EIA Doel 4 - Tihange 3

Technical opinion on the EIA report

Answers to questions raised in the report by Umweltbundesamt GmbH, Austria

Evaluation of Belgium answer to

LTO programme Doel 4 and Tihange 3 (2023-2028)

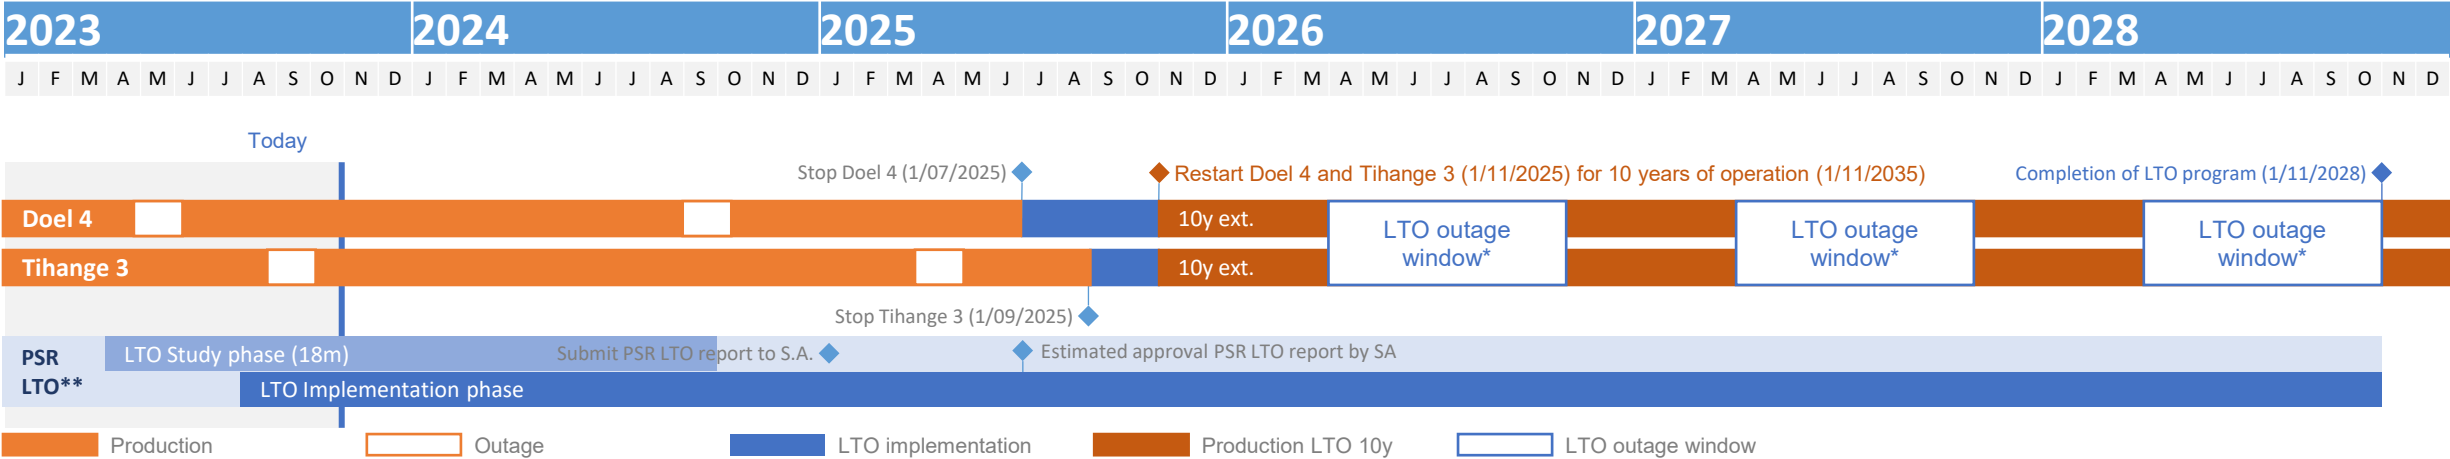
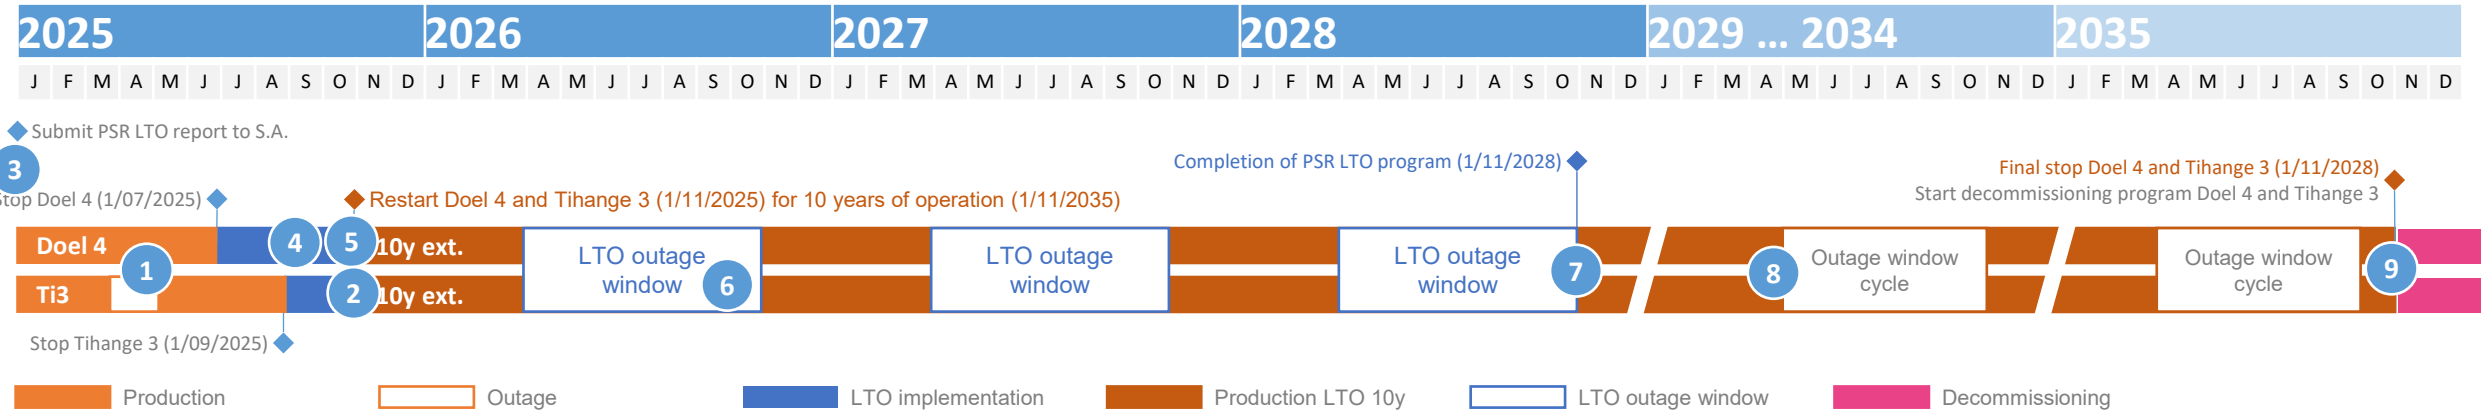
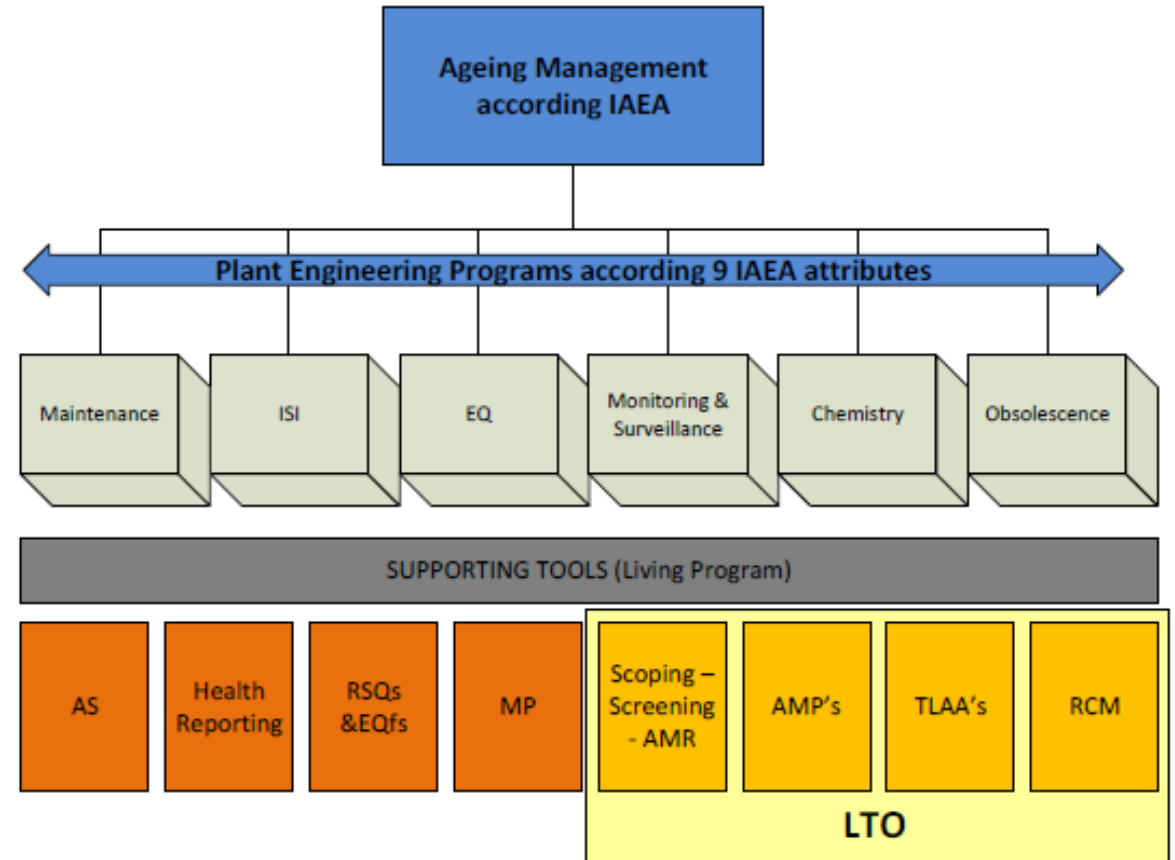
Question 4

Timeline of all the activities planned,
depicting safety upgrades and eventual
LTO degradations

1. On 1 July 2025 Doel 4 will be shut down after 40 years of operation. Tihange 3 will follow 2 months later. For Doel 4, the last regular outage will take place around September 2024 and for Tihange 3 in April 2025.

5. The safety authorities will give green light to restart our units once a predefined list of activities has been completed.

6. Other works may be performed after restart as long as everything is finished within 3 years after restart. Derogations are only possible if formal approval by safety authorities. This gives us 5 years to complete the entire LTO program, from the start of the study phase in 2023 until the last works in 2028. A further constraint is that we have agreed with the Belgian government to have both units operational during winter months.

7. The implementation will take about 5 years with a peak of activities during planned extended outages outside winter periods. The LTO implementation, and by extension the entire PSR LTO programme, will end with the last action on the Global Action List (GAL) completed.

Provide the time schedule mentioned in the answer

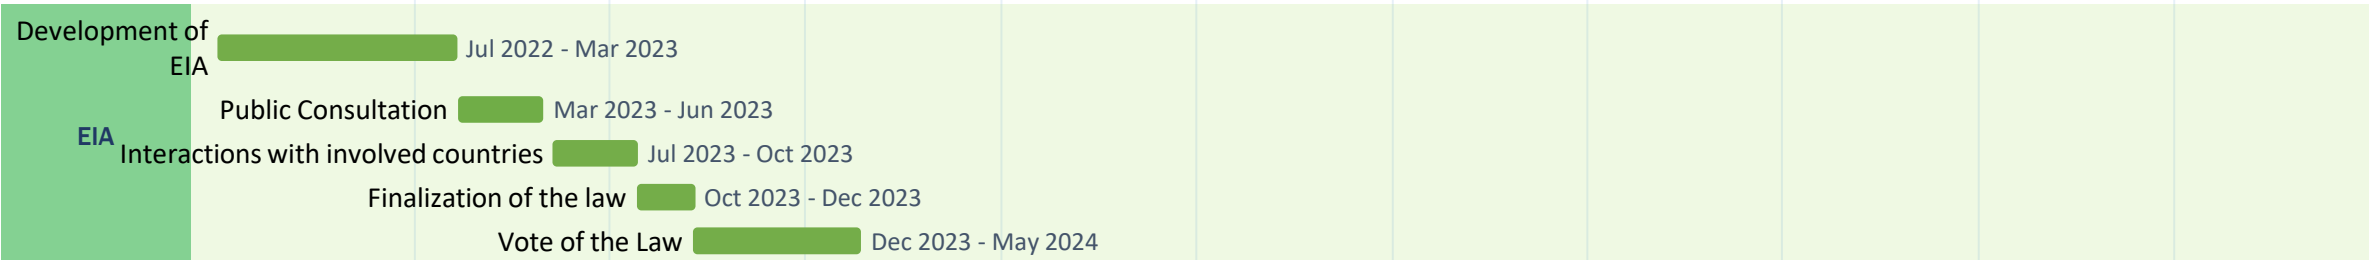
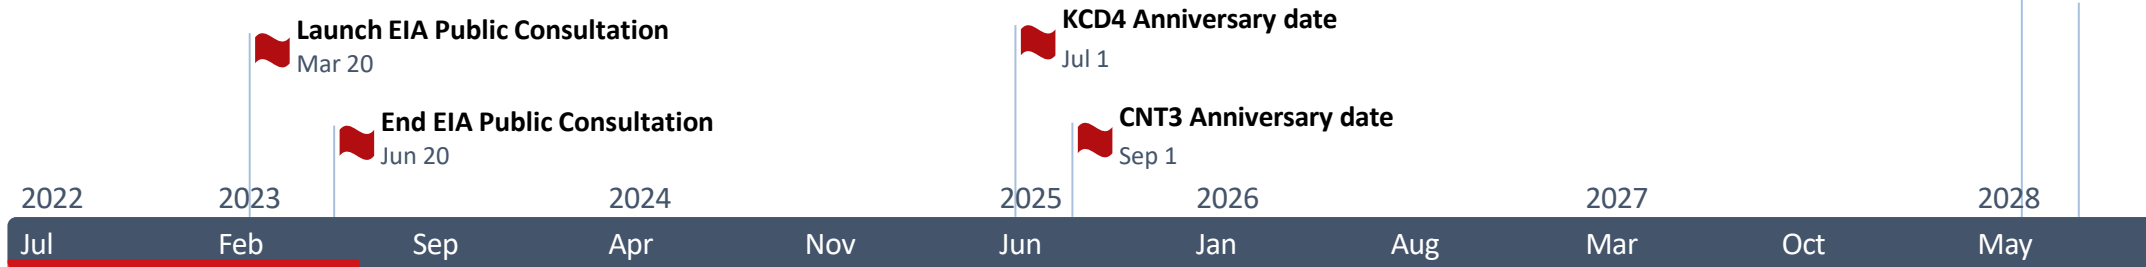
Question 5

* Timeline shown is as was given in the answers provided to Austria.
